# UNITED STATES PATENT AND TRADEMARK OFFICE

09/934,178

Brian J. Brown

<b>Office Action Summary</b>	<b>Application No.</b>	<b>Applicant(s)</b>	
	09/934,178	BROWN ET AL.	
	<b>Examiner</b>	<b>Art Unit</b>	
	Paul B. Prebilic	3738

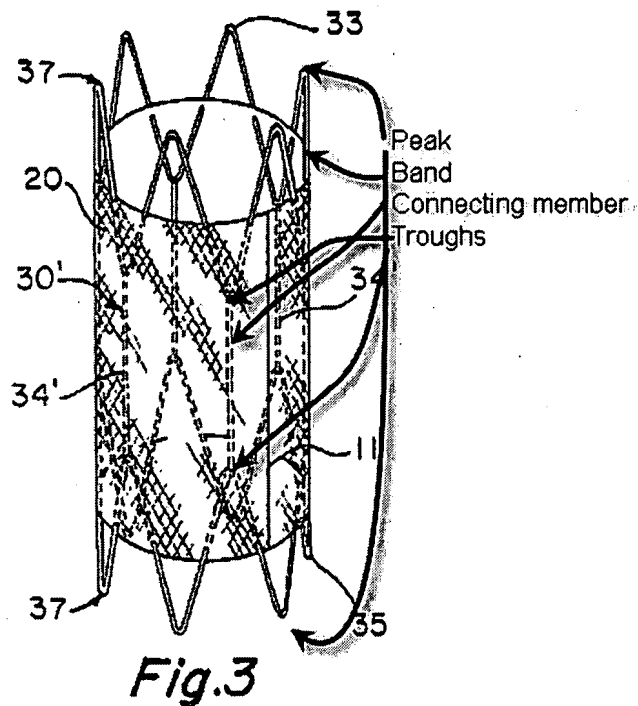
Claims 17 and 19 are rejected under 35 U.S.C. 102(e) as being anticipated by Robinson et al (US 5,935,161). Robinson anticipates the claim language where the peaks as claimed are the pointed ends of the portions of the segments (33 and 35) that extend past the graft in Robinson; see Figure 3.

Applicants traverse the Robinson rejection by stating that it is not clear what elements of Robinson's device correspond to the bands, connecting members, peaks and troughs as claimed. The Examiner though and still thinks that these elements are clear based upon the rejection as stated currently and previously. However, in order to help the Applicants' understanding of the rejection, the following marked up drawing is provided below:
